STAFF REPORT: JUNE 12, 2024, REGULAR MEETING **PREPARED BY:** T. BOSCARINO
APPLICATION NUMBER: HDC2024-00204; HDC2024-00275
ADDRESS: 971 BURNS
HISTORIC DISTRICT: INDIAN VILLAGE
APPLICANT: EMMA BORNGESSER, BRUTTELL ROOFING; DENINE NGOYI
OWNER: DENINE NGOYI
DATE OF PROVISIONALLY COMPLETE APPLICATION: MAY 21, 2024
DATE OF STAFF SITE VISIT: MAY 23, 2024

SCOPE: REPLACE WOOD SHINGLE ROOF ON HOUSE WITH ASPHALT SHINGLE ROOF, REPLACE ASPHALT SHINGLE ROOF ON GARAGE, OTHER GARAGE REPAIRS

West wall (left) and chimney (right). Photos from application materials.

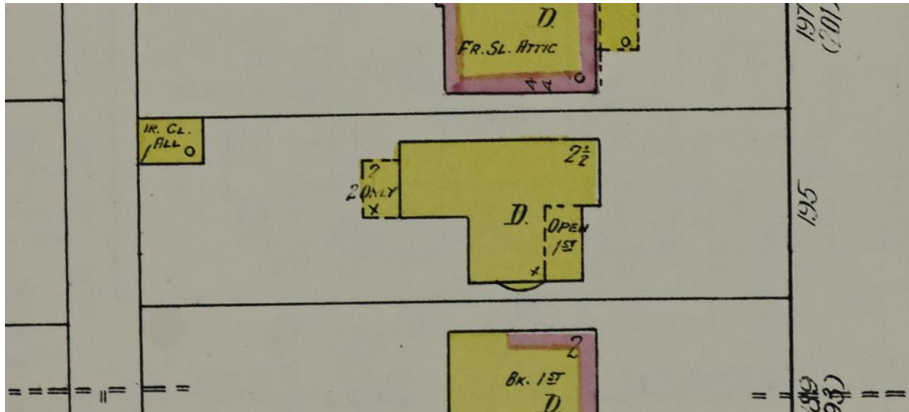
The applicant proposes to rebuild the compromised structural clay tile masonry of the alley-facing (west-facing) wall with wood framing. This repair work would result in a loss of the stucco surface, which would be

replaced with new stucco. Existing wood siding would be retained and the ash door would be kept in place.

The proposal would also rebuild the chimney with new brick.

- Asphalt shingles are historically appropriate for the garage.
- The other proposed garage work items would not noticeably change the exterior appearance of the garage, though old stucco will be replaced with new stucco and old chimney bricks will be replaced with new chimney bricks.

Staff concludes that the proposed chimney repair, stucco repair, and garage roofing replacement meets the Secretary of the Interior's Standards for Rehabilitation and therefore recommends that the Commission issue a Certificate of Appropriateness for this work.
